ENGINE - REPLACE AN960 SERIES WASHERS - CATEGORY CODE 6 - MOD.ENG-72-0081

V2500-ENG-72-0081

Replacement of Washer - EEC Fan Harness
Fig.1

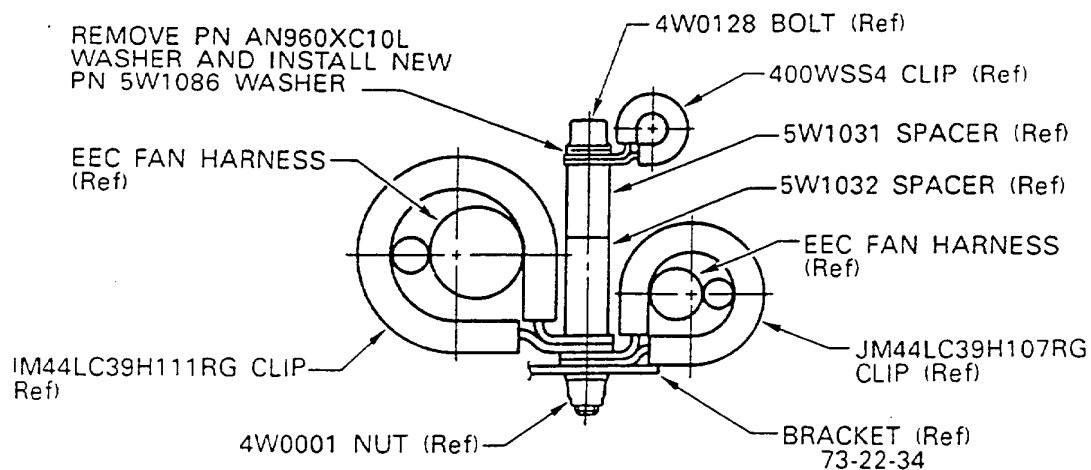
- (a) At CP0796, AN960XC10L, EEC Fan Harness clipping Washer is replaced by 5W1086, Washer (see Fig.1).
 - (b) AN960C8, Washers which attach the EEC Core Harness to the NF Electrical Harness terminal are replaced by MS9321-08, Washers (see Fig.2).

- (1) At CP0796, install the new 5W1086, Washer, to the EEC Fan Harness by the approved procedures in the Engine Manual, 72-00-32, Installation, TASK 72-00-32-420-004. (Refer to Fig.1, and 1.K. References (1) and (2)).

Replacement of Washers - EEC Core Harness
Fig.2

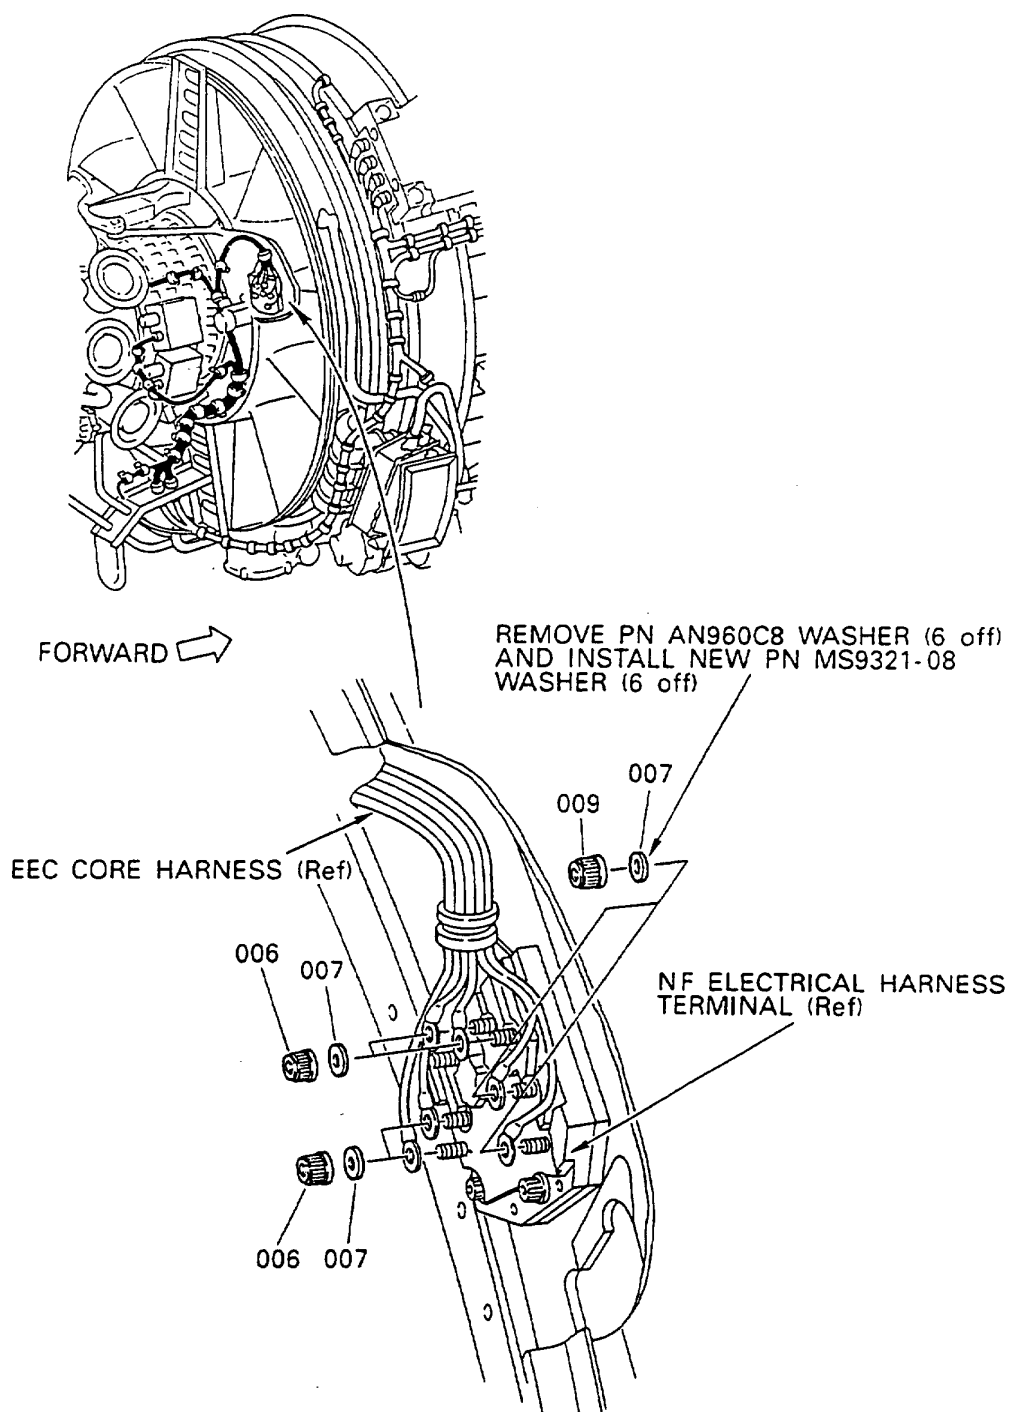
- (2) Install the six new MS9321-08, Washers, to attach the EEC Core Harness to the NF Electrical Harness terminal by the approved procedures in the Engine Manual, 72-00-40, Installation, TASK 72-00-40-420-006. (Refer to Fig.2, and 1.K. References (1) and (2)).

Replacement of Washers - LP Compressor/Intermediate Case Module
Fig.3

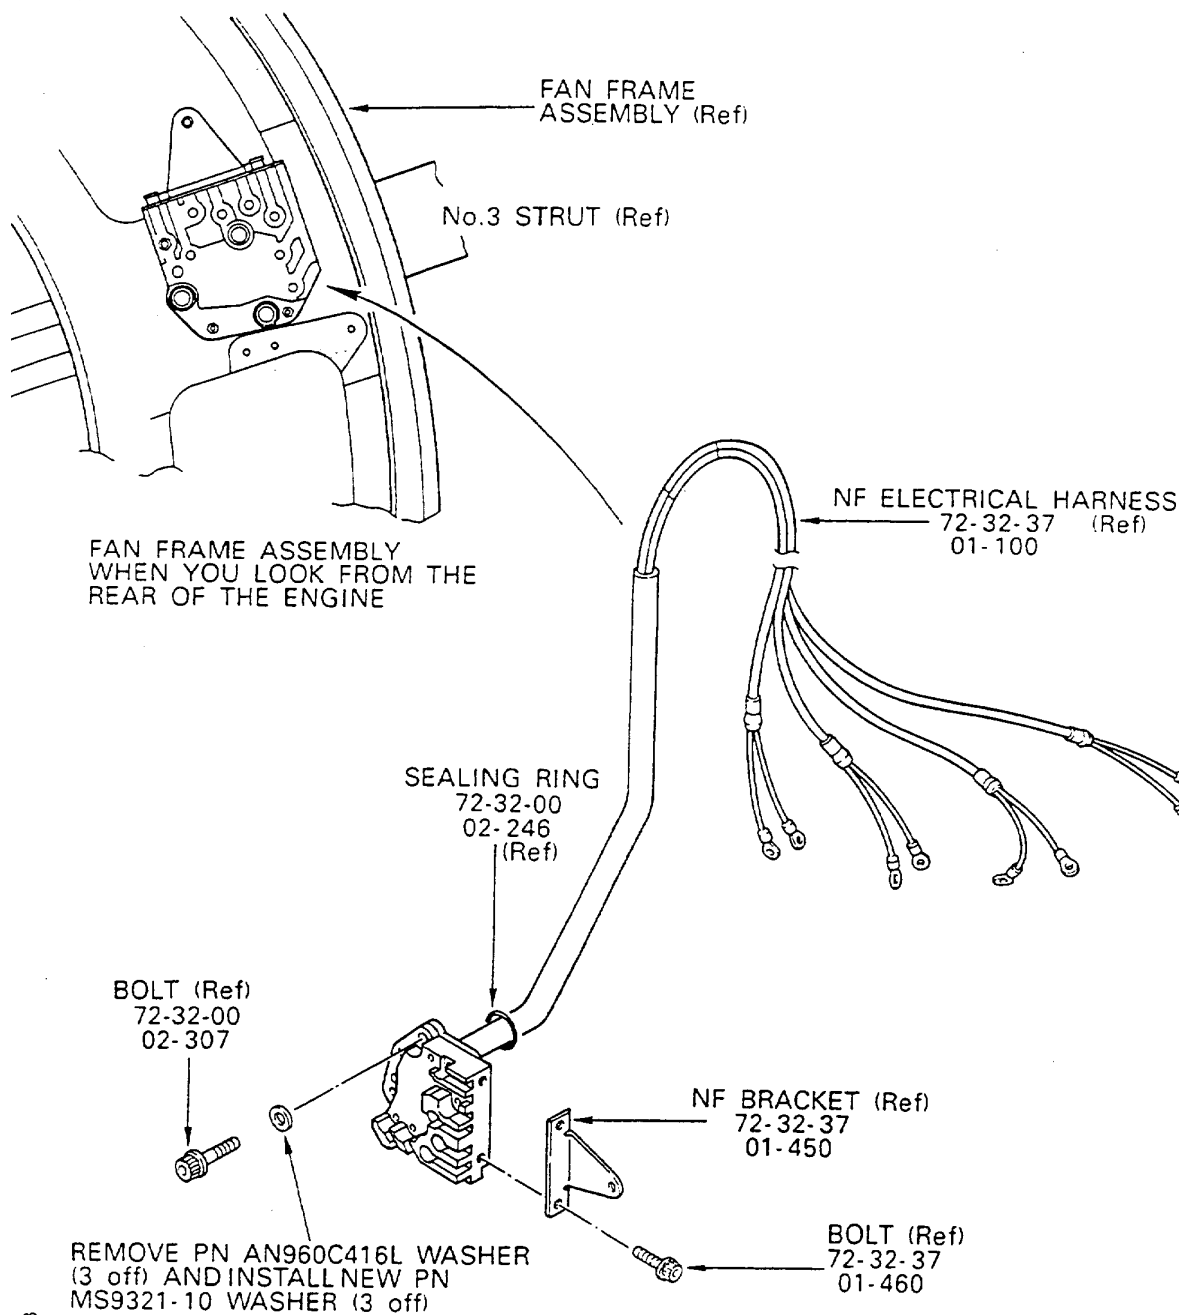
- (c) AN960C416L, Washers which attach the NF Electrical Harness to the Fan Frame Assembly are replaced by MS9321-10, Washers (see Fig.3).
 - (d) AN960C416, Washers which attach the No.1 and No.6 Struts Fairing Panels are replaced by MS9321-10, Washers (see Fig.4).

- (3) Install the three new MS9321-10, Washers, to attach the NF Electrical Harness to the Fan Frame Assembly by the approved procedures in the Engine Manual, 72-32-00, Assembly, TASK 72-32-00-430-004. (Refer to Fig.3, and 1.K. References (1) and (2)).

Replacement of Washers - Fan Frame Assembly
Fig.4

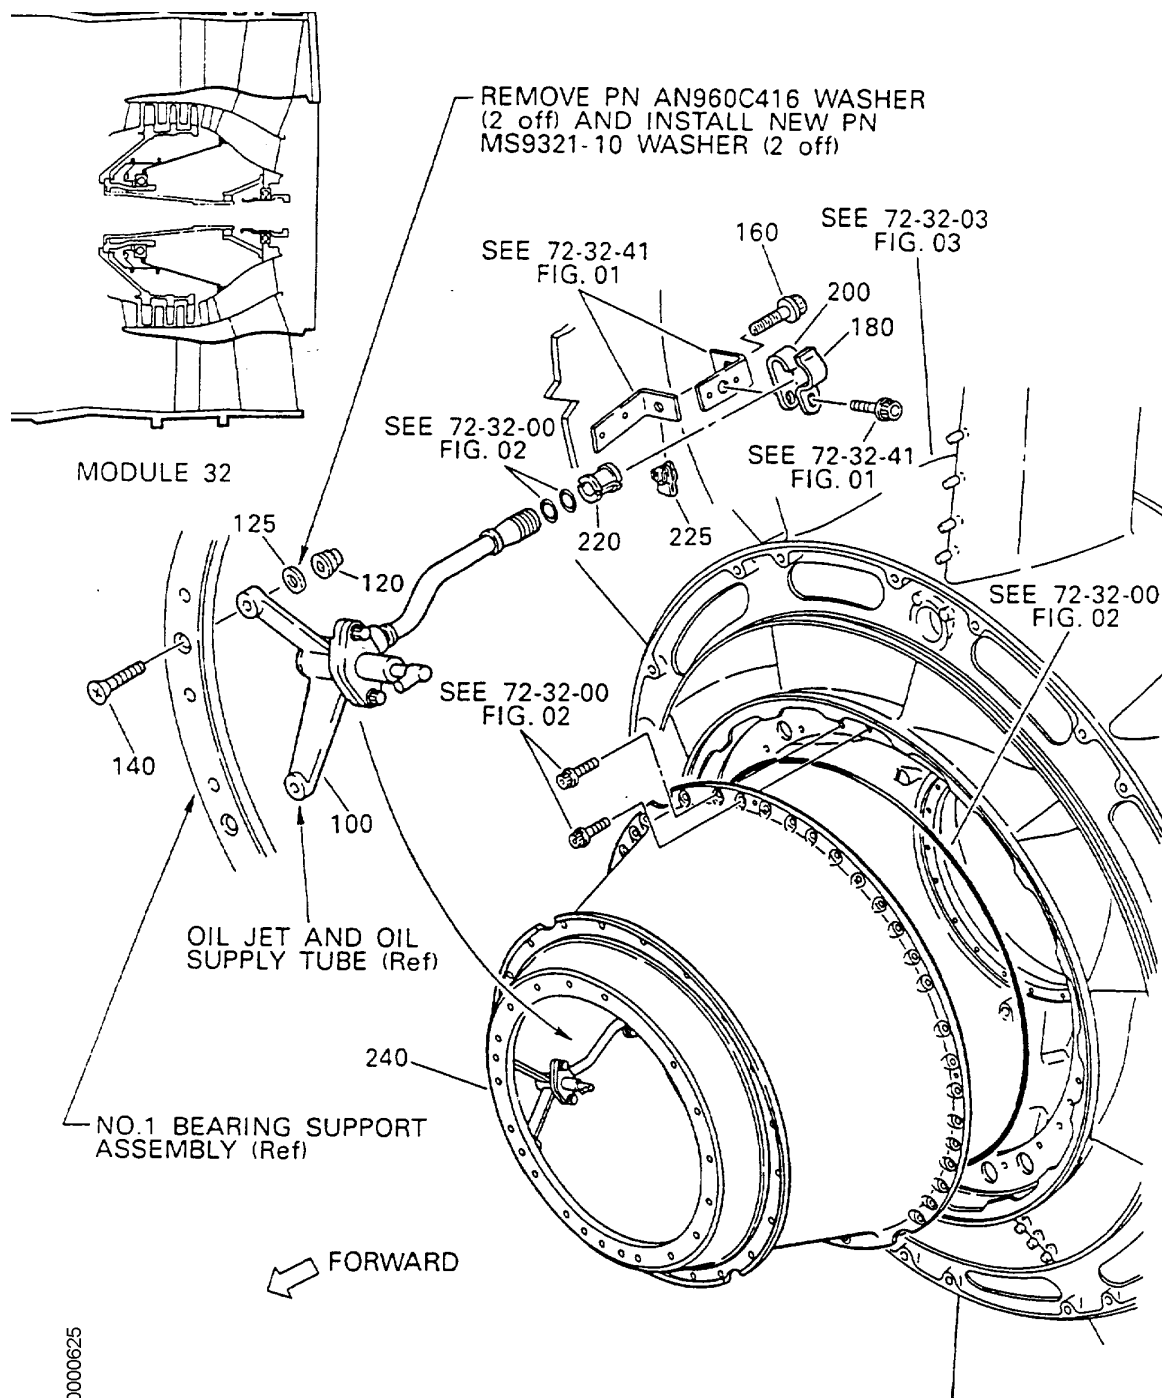
- (4) Install the four new MS9321-09, Washers and the three new MS9321-10, Washers to attach the No.6 Strut Fairing Panel to the Fan Frame Assembly, and install the four new MS9321-09, Washers, and each three new MS9321-10, Washers, to attach the No.1 Strut Fairing Panel to the Fan Frame Assembly, by the approved procedures in the Engine Manual, 72-32-00, Assembly, TASK 72-32-00-430-014. (Refer to Fig.4, and 1.K. References (1) and (2)).

Replacement of Washers - Oil Jet and Oil Supply Tube
Fig.6

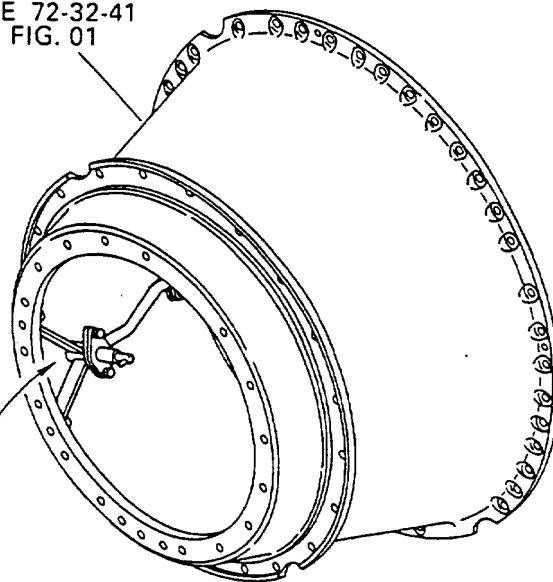
- (6) Install the two new MS9321-10, Washer, to attach the No.1 Bearing Oil Jet to the Strainer Housing by the approved procedures in the Engine Manual, 72-32-40, Assembly, TASK 72-32-40-440-001. (Refer to Fig.6 and 1.K. References (1) and (2)).

REMOVE PN AN960C416 WASHER
(2 off) AND INSTALL NEW PN
MS9321-10 WASHER (2 off)

Replacement of Washers - LP Compressor Stage 1.5 and 2 Vanes
Fig.8

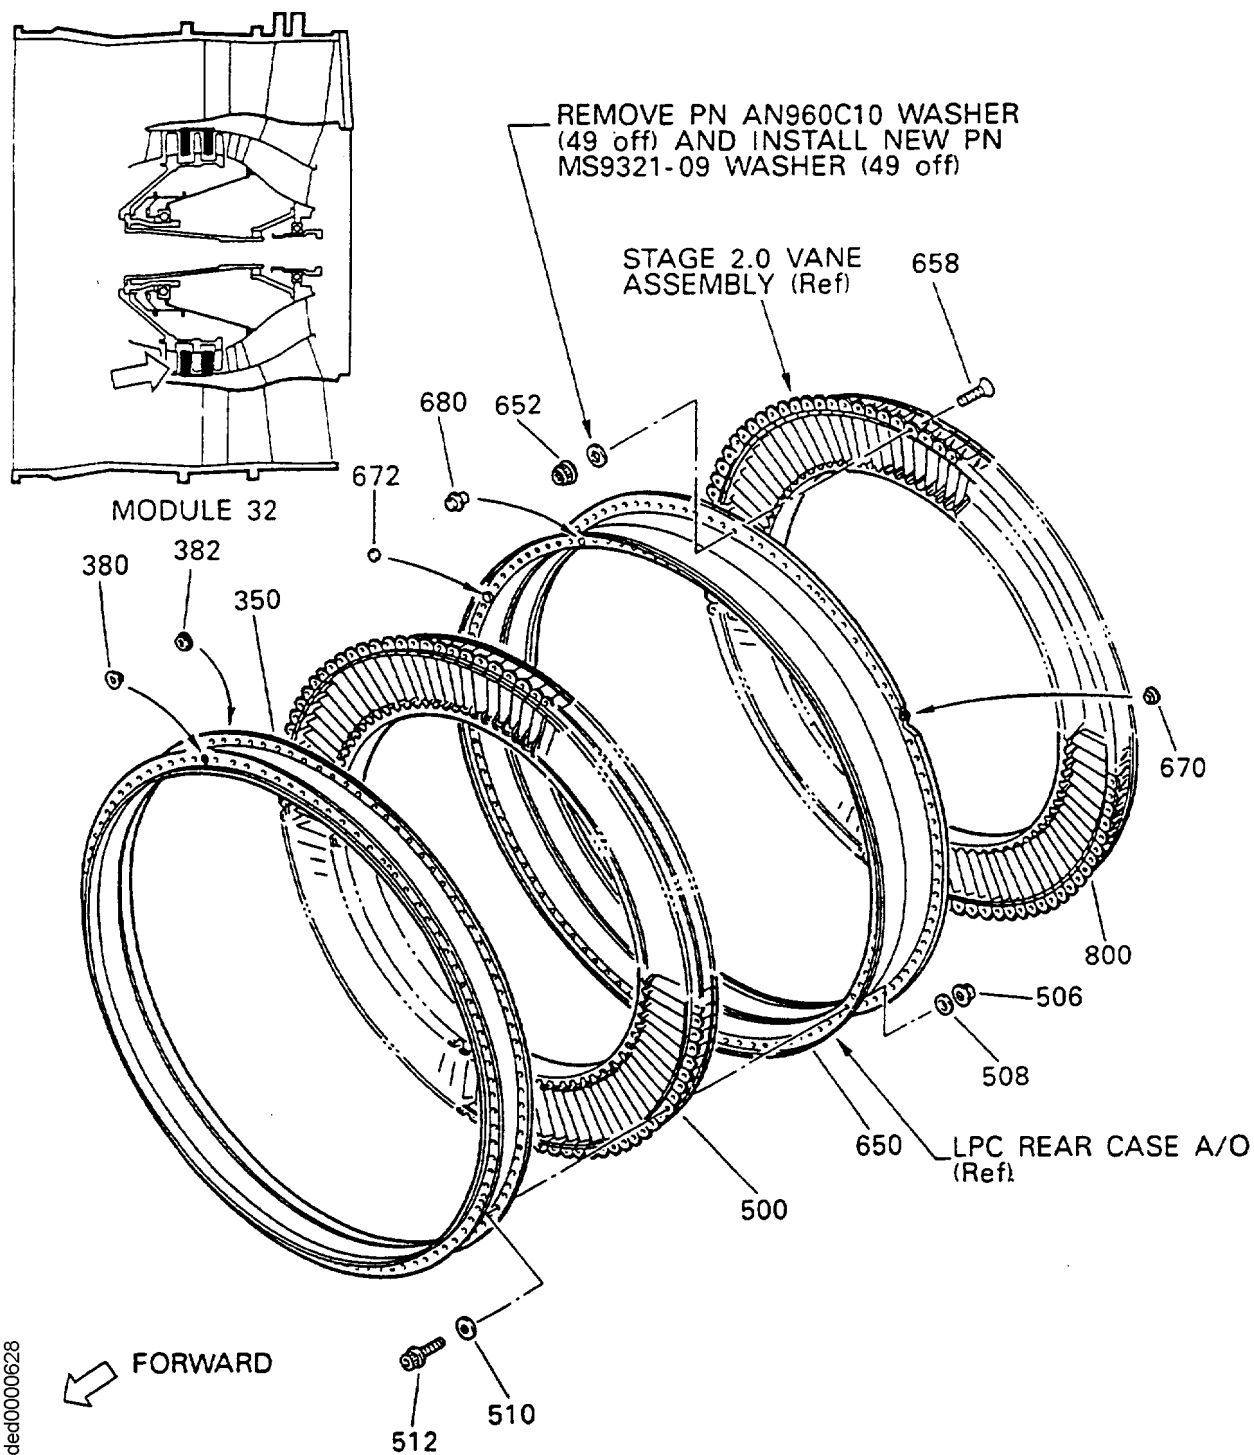
- (8) Install the forty nine new MS9321-09, Washers, to attach the LPC Rear Case to the LPC Stage 2.0 Vane Assembly the the approved procedures in the Engine Manual, 72-32-80, Assembly, TASK 72-32-80-040-001. (Refer to Fig.8, and 1.K. References (1) and (2)).

Replacement of Washers - Fan Case
Fig.9

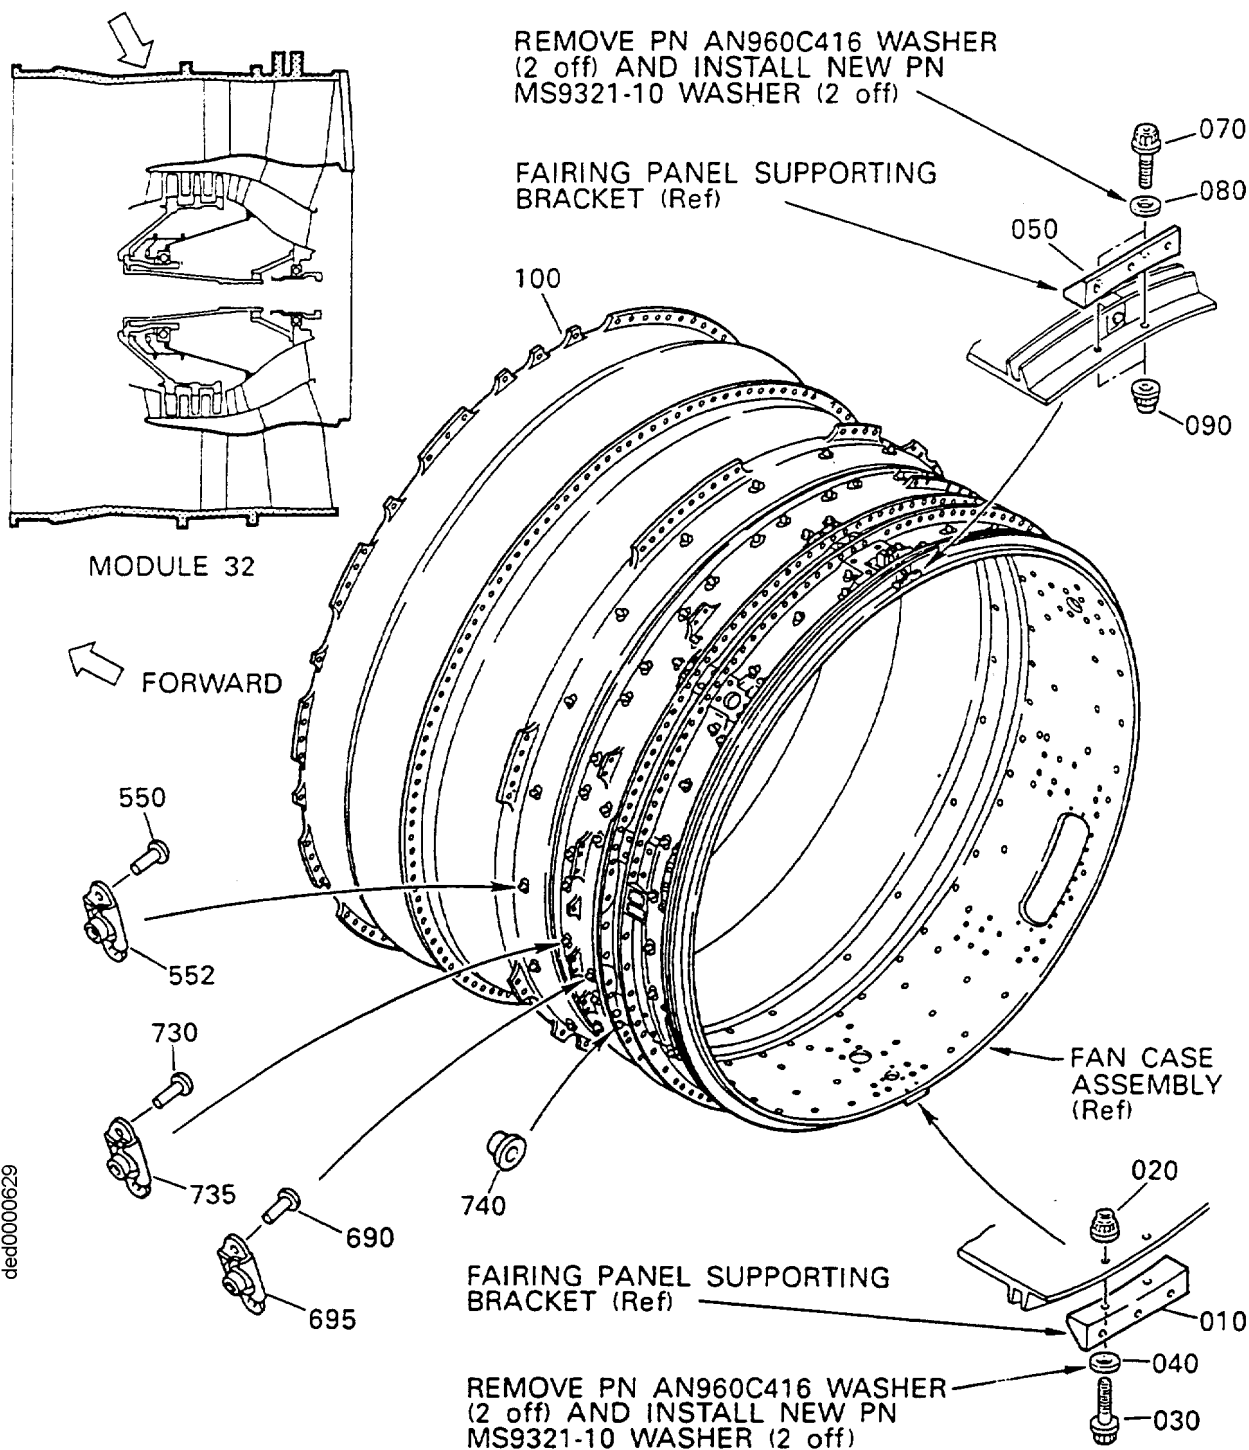
- (9) Install each two new MS9321-10, Washers, to attach the Fairing Panel Supporting Brackets to the Fan Case by the approved procedures in the Engine Manual, 72-32-00, Assembly, TASK 72-32-00-430-014. (Refer to Fig.9, and 1.K. References (1) and (2)).

Replacement of Washers - LP/HP Fuel Pumps
Fig.10

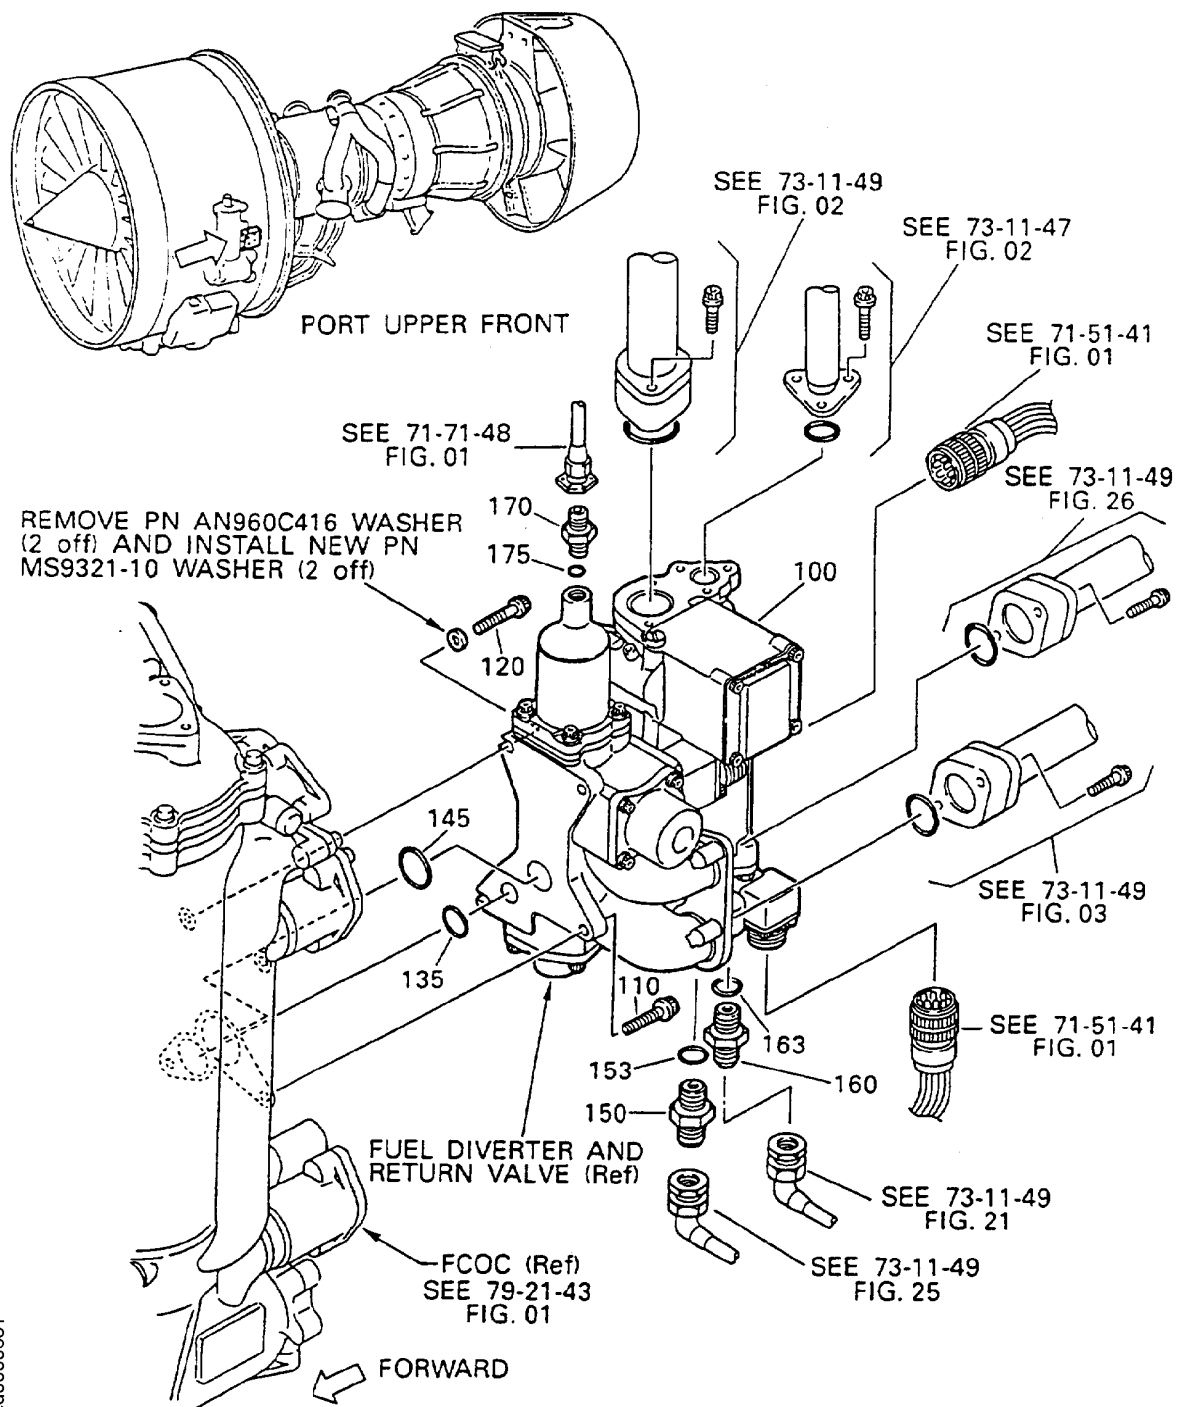
- (10) Install the four new MS9321-11, Washers, to attach the Adaptor Housing to the Gearbox Casing by the approved procedures in the Engine Manual, 72-00-60, Installation, TASK 72-00-60-420-001-002. (Refer to Fig.10, and 1.K. References (1) and (2)).
